Access Compliance Report

Public Rights-of-Way

(Curb Ramps)

Intersection ID: 30374	Main Street: EASTWAY_CROSSING_DR	Cross Street: EASTWAY_DR	Location: NE
ADA ID: 6B43C62D128A	Ramp Type: Perp	Initial Pass/Fail: Fail	Overall Compliance: No
Codes/Mitigation Info/Possible Solution		Field Measurements/Component Compliance	
Severity Score: 33.75

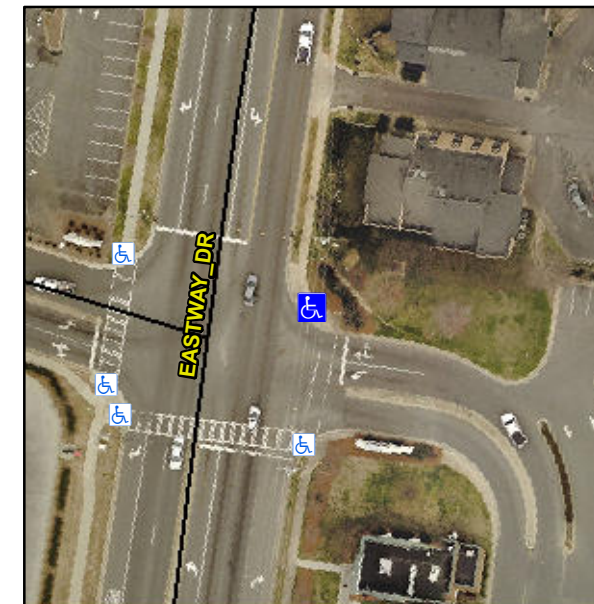
Not Found, R304.5.1, R304.2.2, R304.5.3

Compliance	Description	Data	Compliance	Description	Data
N/A	Ramp Length (in)	99.0	No	Ramp Slope (%)	10.2
No	Ramp Width (in)	36.5	No	Ramp XSlope (%)	5.1
N/A	Flare Type LT	N/A	N/A	Flare Type RT	N/A
N/A	Flare Slope LT (%)	N/A	N/A	Flare Slope RT (%)	N/A
N/A	Flare Traversable LT?	N/A	N/A	Flare Traversable RT?	N/A
N/A	Landing Length (in)	N/A	N/A	DWS Provided?	N/A
N/A	Landing Width (in)	N/A	N/A	DWS Contrast?	N/A
N/A	Landing Slope (%)	N/A	N/A	DWS Length (in)	N/A
N/A	Landing X Slope (%)	N/A	N/A	DWS Full Width?	N/A
N/A	Landing Curb? (Y/N)	N/A	N/A	DWS Offset (in)	N/A
N/A	Shared Landing?	N/A			
N/A	Gutter Ponding?	N/A	N/A	Gutter Slope (%)	N/A
N/A	Gutter Lip Ht (in)	N/A	N/A	Gutter X Slope (%)	N/A
N/A	Painted X Walk1?	Yes	N/A	Painted X Walk2?	N/A
	X Walk 1 Direction	To S		X Walk 2 Direction	N/A
N/A	X Walk 1 Width (in)	83.0	N/A	X Walk 2 Width (in)	N/A
	X Walk 1 Slope (%)	0.5		X Walk 2 Slope (%)	N/A
	X Walk 1 X Slope (%)	2.4		X Walk 2 X Slope (%)	N/A

Remove & Replace Entire Ramp.
